**SUBJECT: RESPONSE TO NOTICE OF DEFICIENCY CONCERNING OPERABLE
UNIT 1130 FIELD INVESTIGATION WORK PLAN
ACTIVITY DATA SHEET NUMBER 1130
(WBS #) 1.4.2.6.1.19.1.2**

LIST OF DEFICIENCIES, DISCUSSION, AND
PROPOSED TEXT CHANGES
RFI WORK PLAN FOR OPERABLE UNIT 1130

Figure 3-7. Groundwater flow in the main aquifer and water wells in the vicinity of OU 1130.

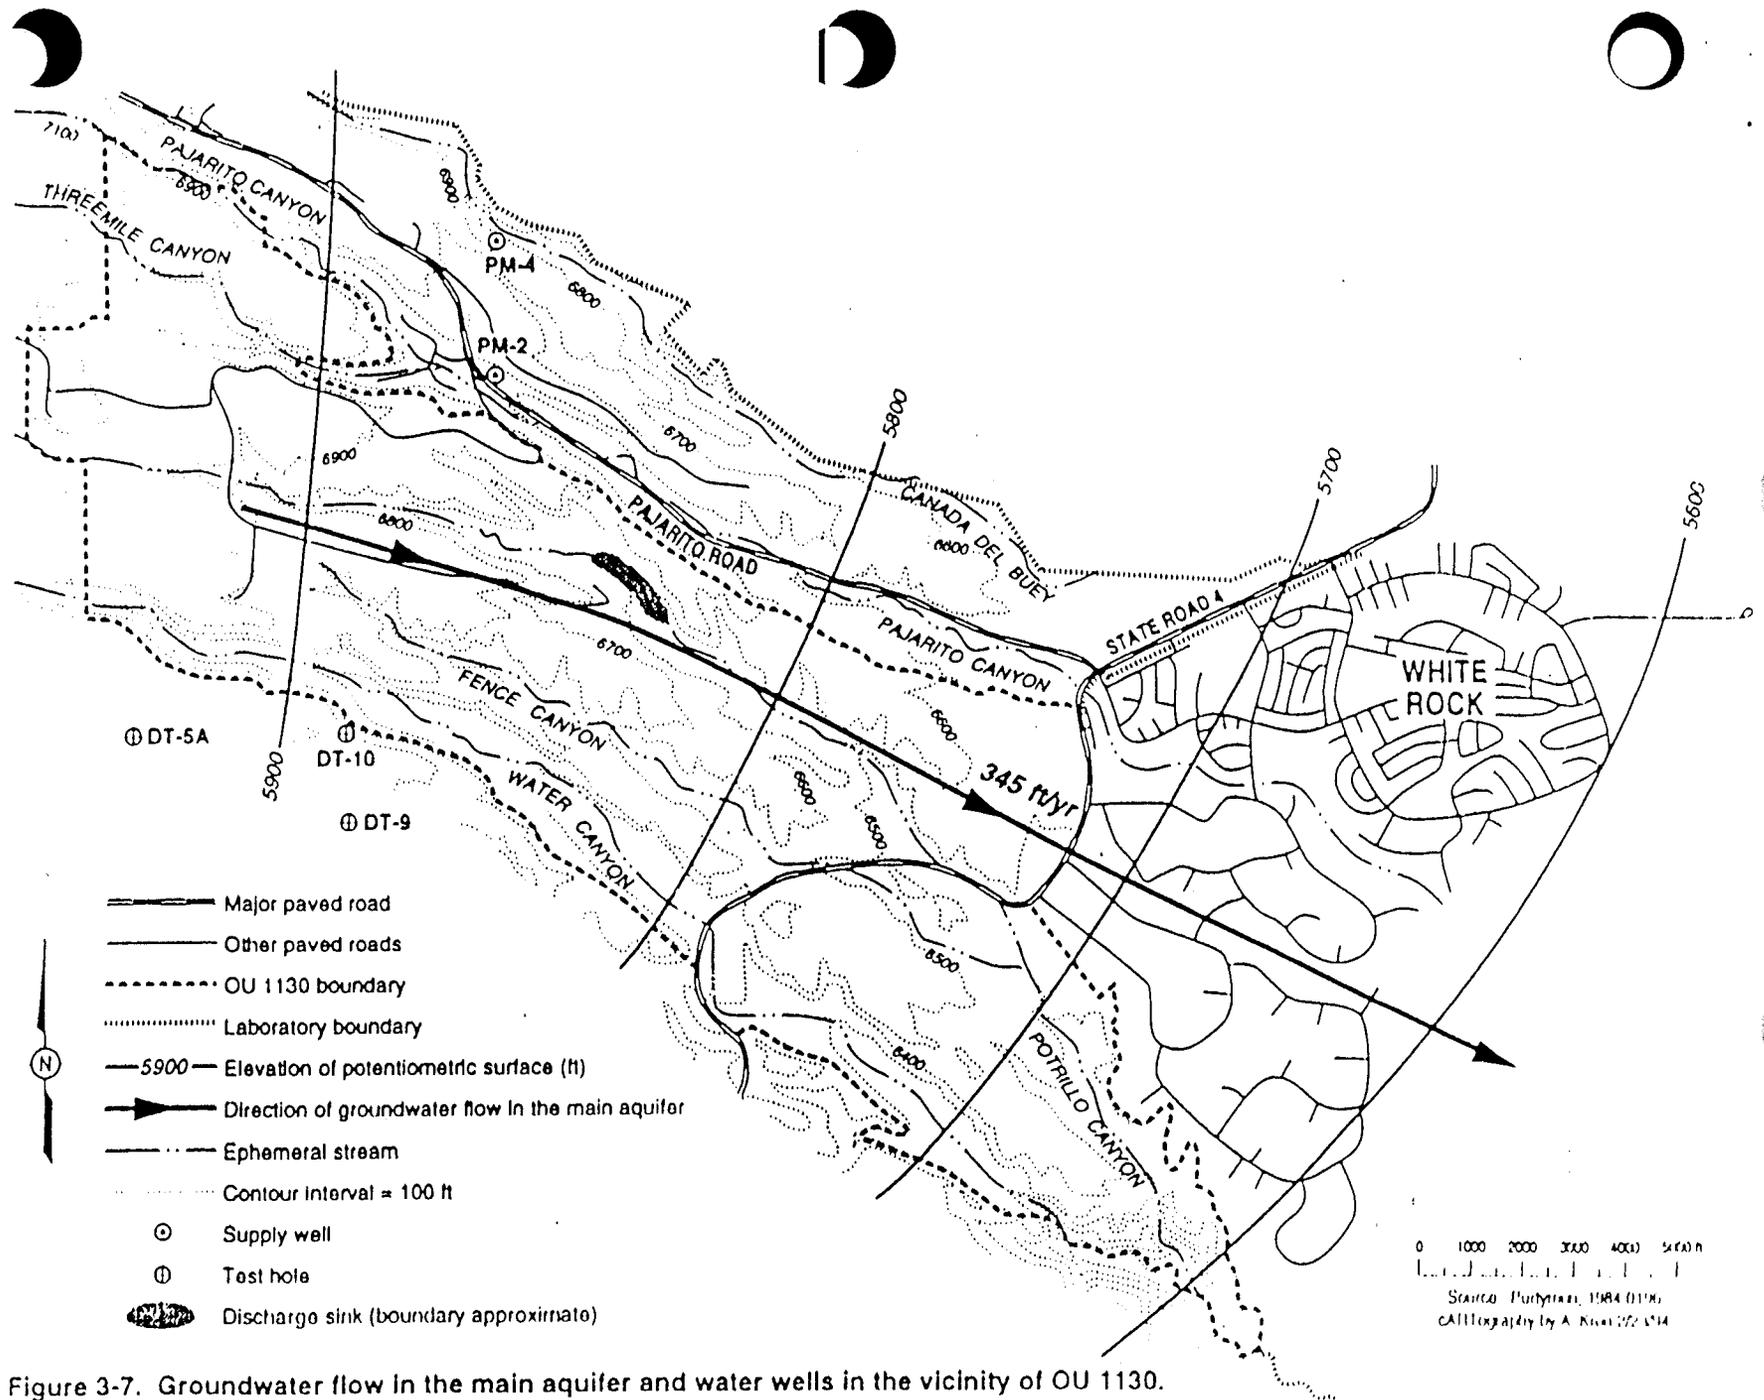
2. 3.5.1.2 Infiltration of Surface Water, p. 3-23

Figure 3.7 does not show the location of the discharge sink in Potrillo Canyon as mentioned in the text. LANL should provide a revised figure showing the location of this sink.

Figure 3-7 has been revised to show the location of the discharge sink in Potrillo Canyon.

Substitute revised Figure 3-7.
